WELL API NO. 30-025-31456	
5. Indicate Type of Lease STATE ☒ FEE ☐	
6. State Oil & Gas Lease No.	
7. Lease Name or Unit Agreement Name	
8. Well Number	91
9. OGRID Number 241333	
10. Pool name or Wildcat [40990] LOVINGTON; UPPER SAN ANDRES, WEST	
4. Well Location Unit Letter D : 1305 feet from the NORTH line and 15 feet from the WEST line Section 08 Township 17S Range 36E NMPM County	
11. Elevation (Show whether DR, RKB, RT, GR, etc.) 3901 GR

SUNDRY NOTICES AND REPORTS ON WELLS
(DO NOT USE THIS FORM FOR PROPOSALS TO DRILL OR TO DEEPEN OR PLUG BACK TO A DIFFERENT RESERVOIR. USE "APPLICATION FOR PERMIT" (FORM C-101) FOR SUCH PROPOSALS.)

Lovington Well P&A Short Procedure for wells with rods and tubing.**All cement plugs are based on 1.18 yield for Class H and 1.32 yield for Class C**

**CONDITIONS OF APPROVAL
FOR PLUGGING AND ABANDONMENT
OCD - Southern District**

Proposed Wellbore Diagram

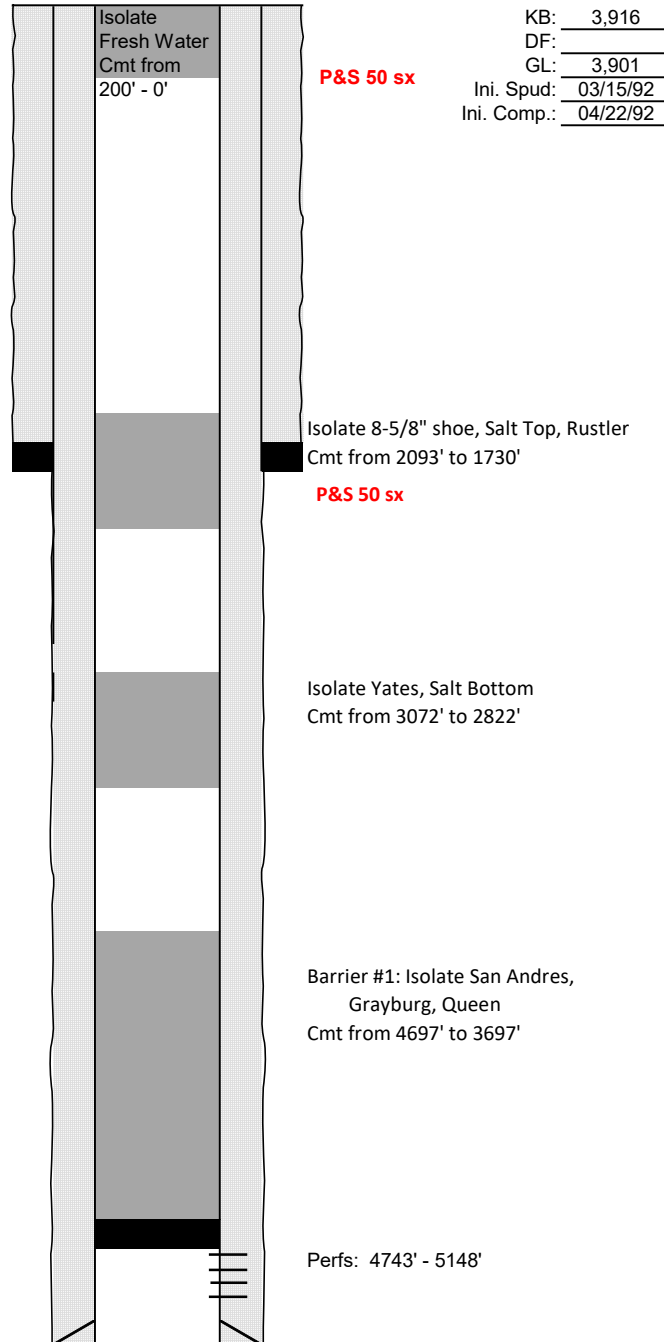
Note changes to procedure

- a. Discuss with NMOCD on waiving WOC and tag if casing passed a pressure test.
19. Spot 25 sacks Class C cement from 3072' to 2822' (Yates).
- ~~P&S 50 sx~~ ~~XX~~ 20. Spot 36 sacks Class C cement from 2093' to 1730' (8-5/8" shoe, Salt, Rustler).

- ~~P&S 50 sx~~ ~~XXX~~ 21. Spot 25 sacks Class C cement from 200' to surface (isolate Fresh Water zone at +/- 100')
22. While RDMO, perform 30-minute bubble test on surface and production casings. Record results to meet the barrier standard intent.
